Addendum 5
TFM-009-24 – GRD-508-23: Concrete & Asphalt Repairs 2024

PROJECT NAME:
CONCRETE AND ASPHALT REPAIRS 2024
Project #: GRD-508-23

Addendum 4
TFM-009-24 – GRD-508-23: Concrete & Asphalt Repairs 2024

3
C-1.7

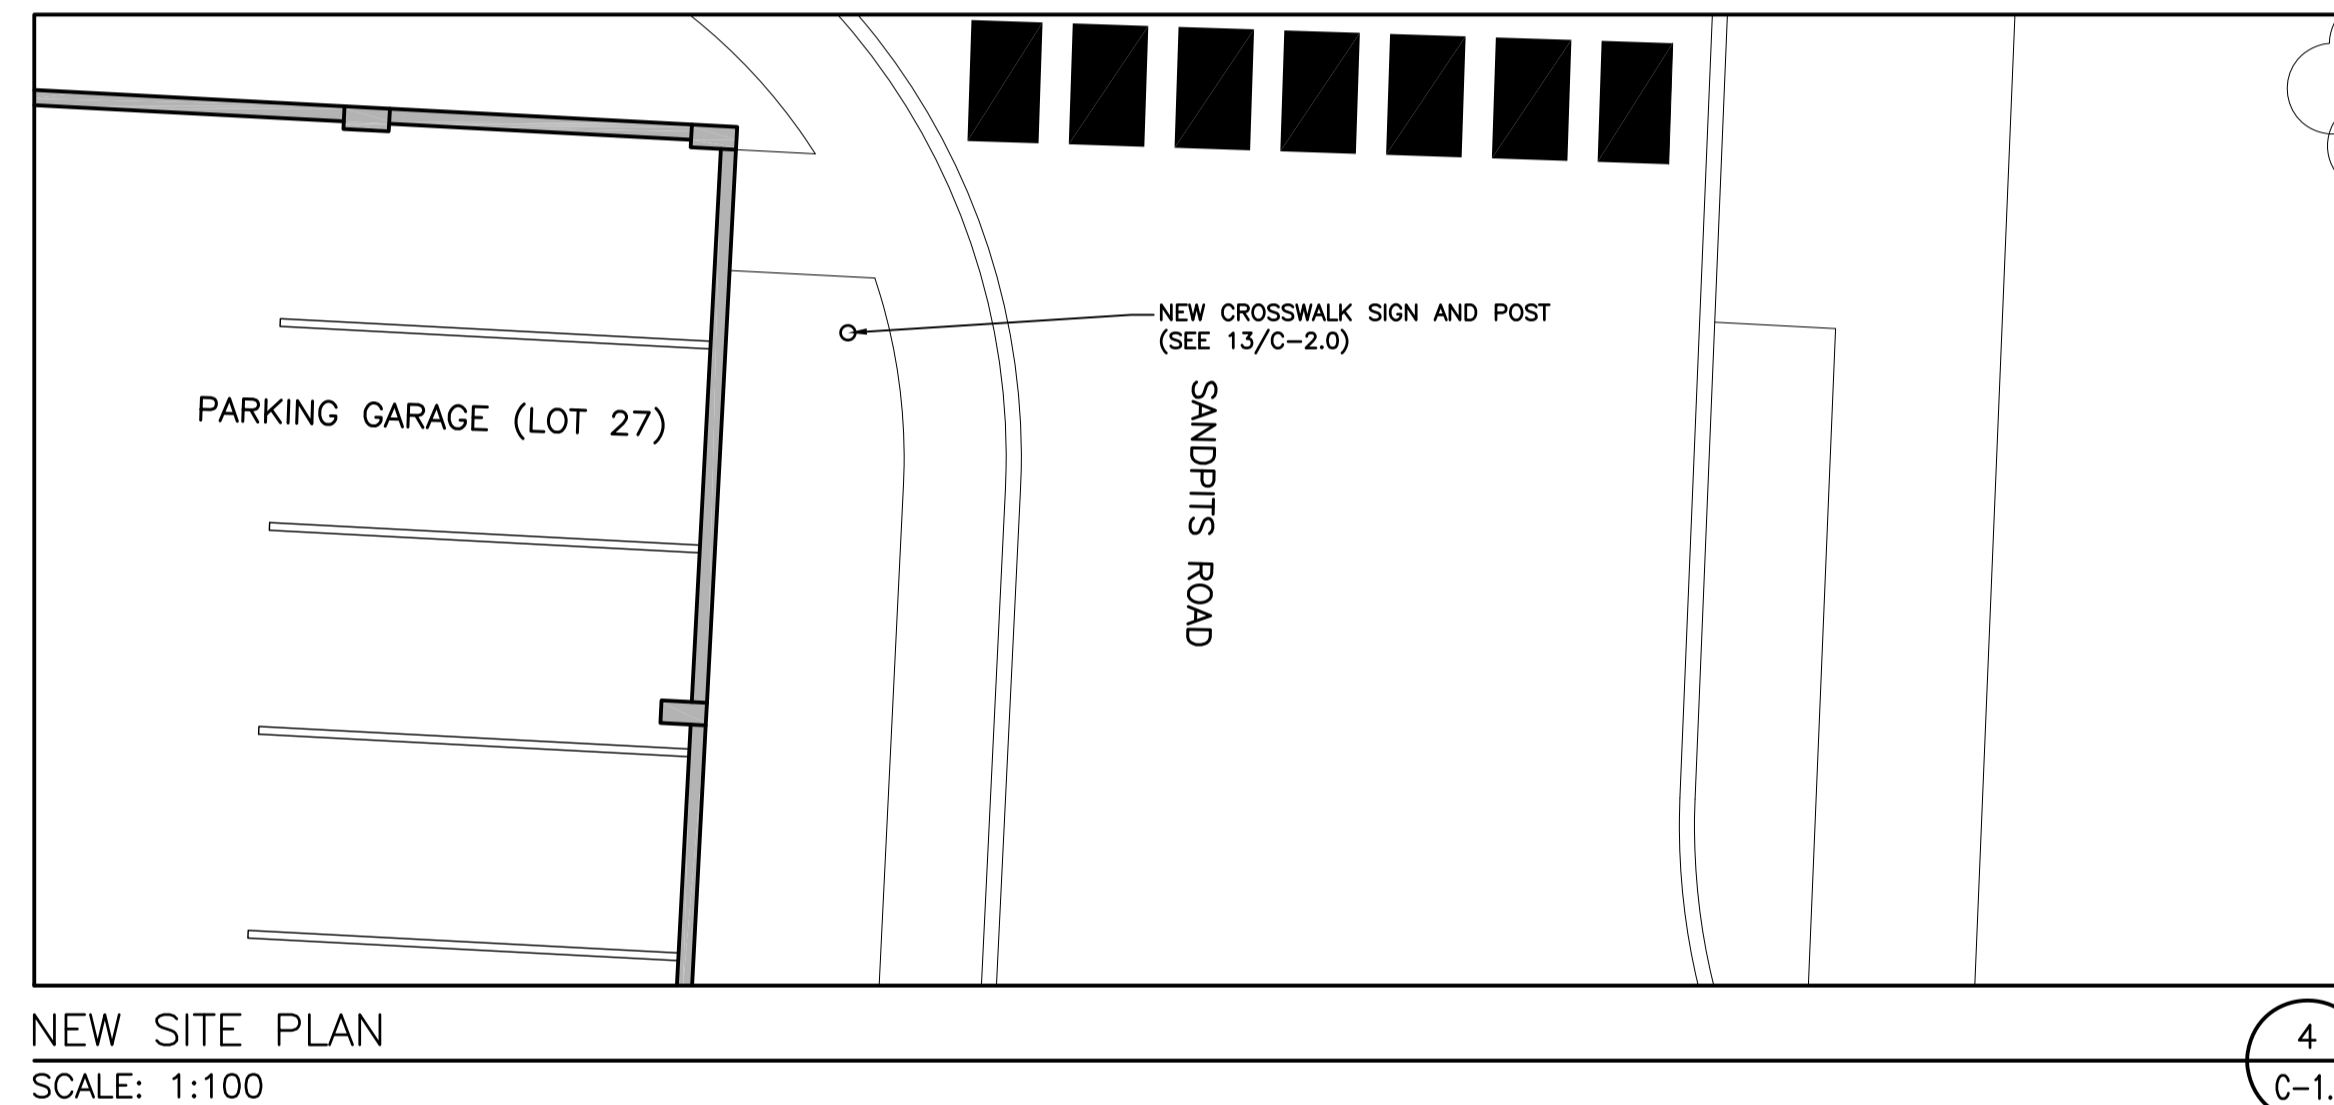
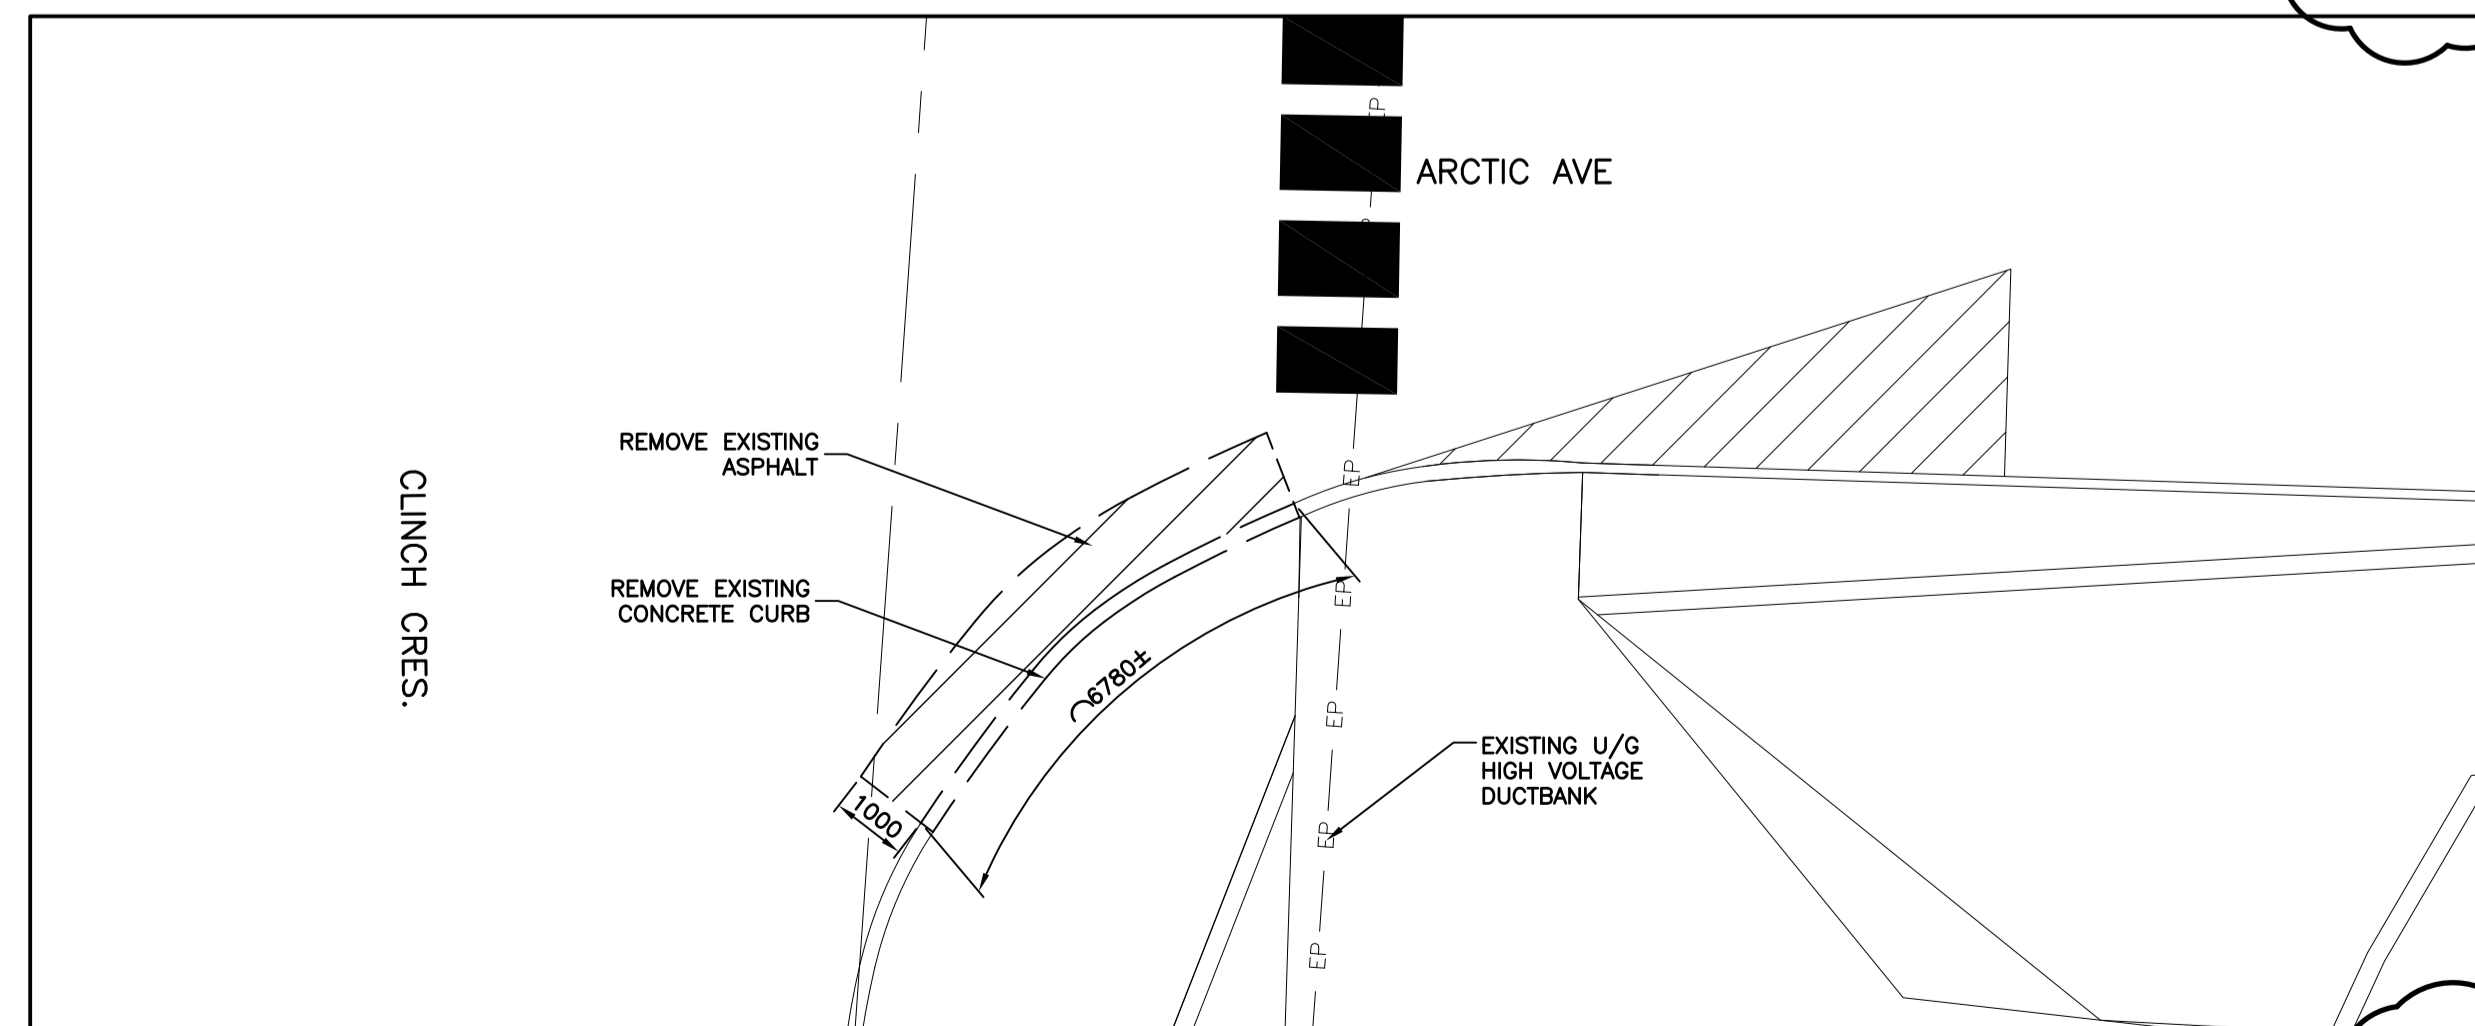
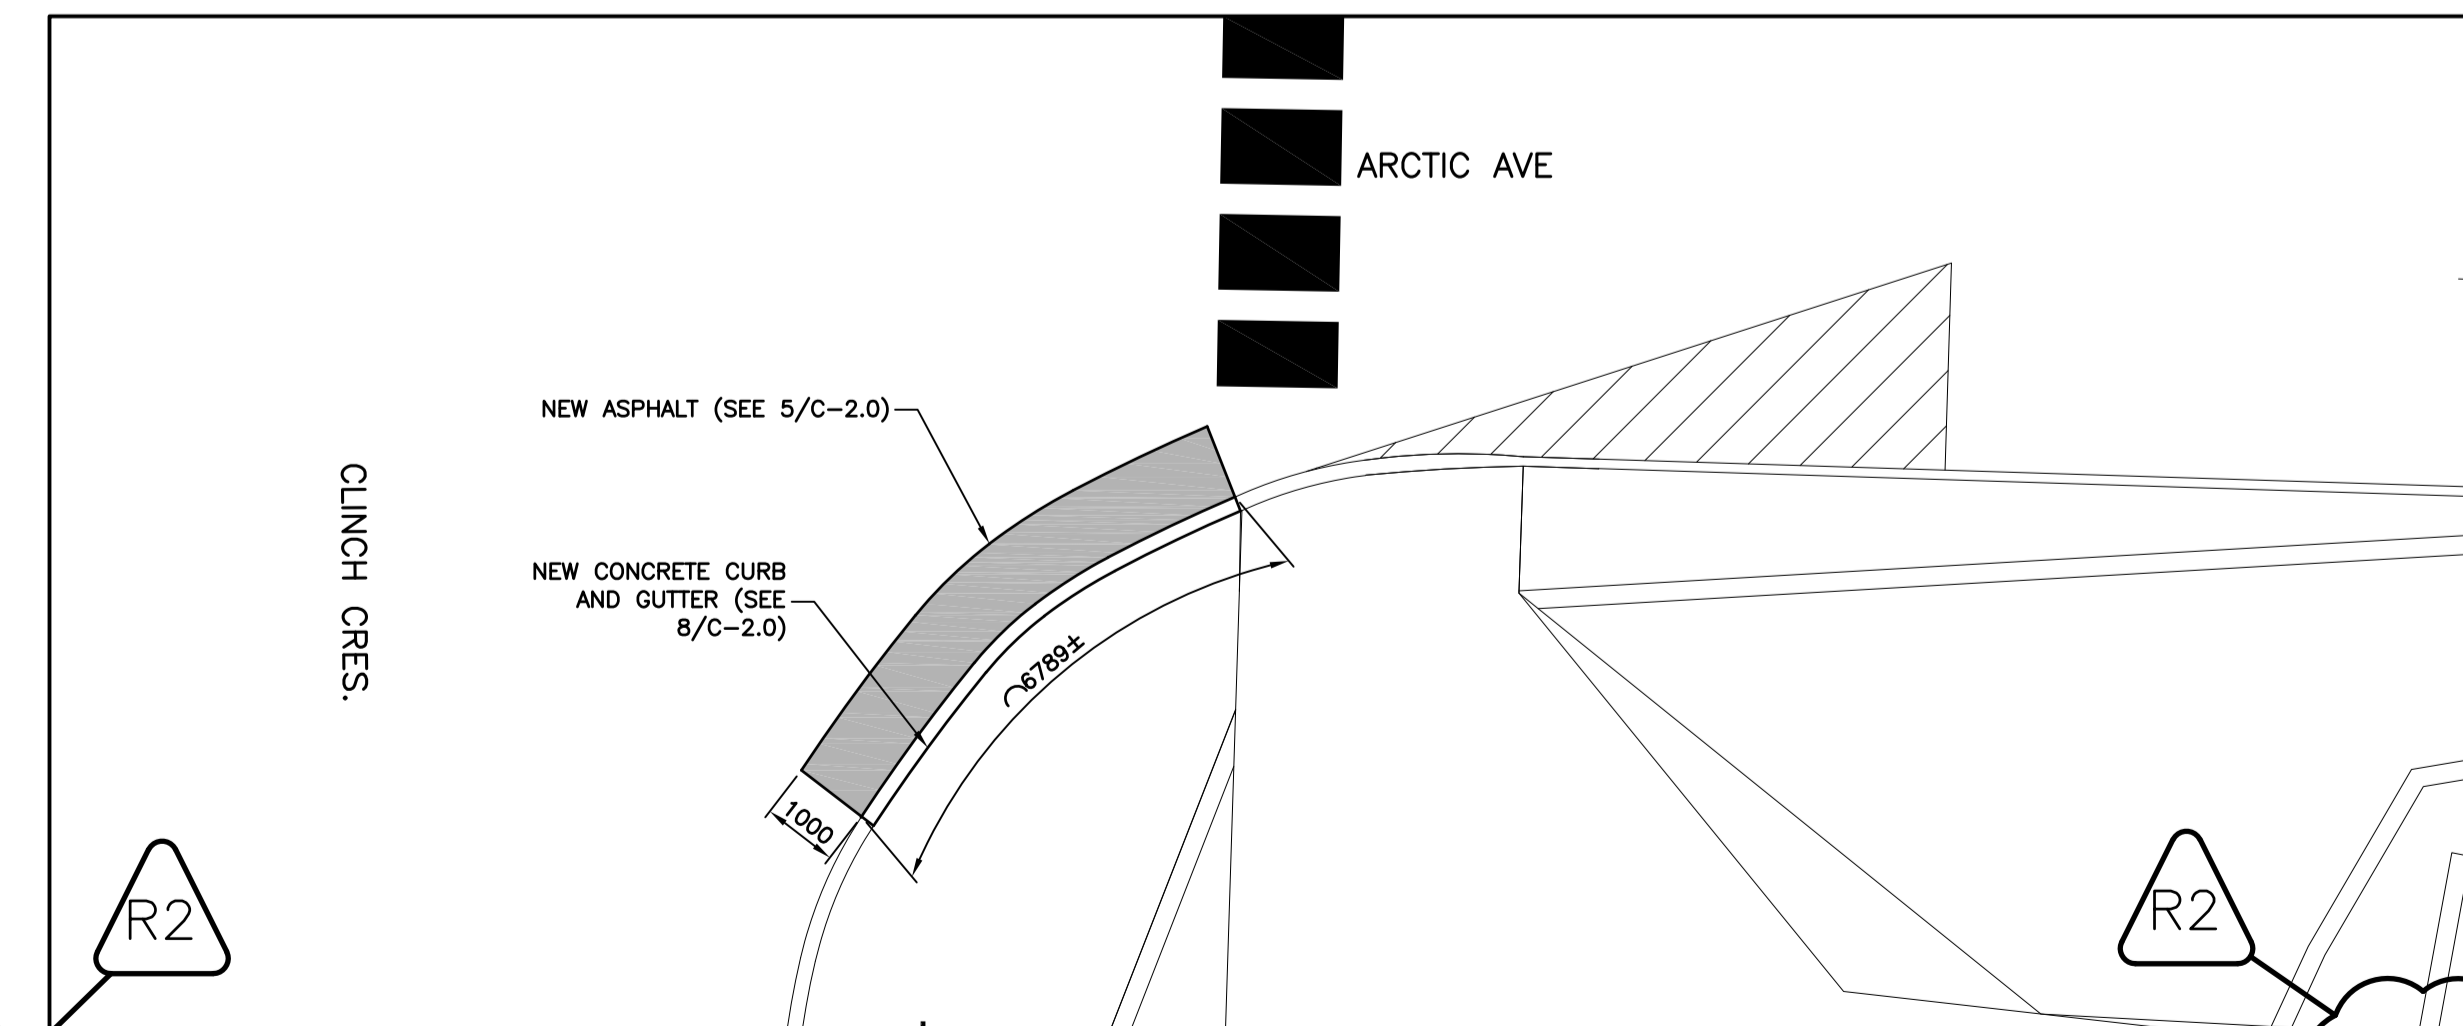
- .4 *Drawings C1.7 series do not line up with the master drawing sheet. 5 shows up as 4. 3/4 appears to be 5/6 and 1/2 appears to be 1/2/3*

RESPONSE: Drawing C-1.7 has been revised and reissued as part of this addendum.
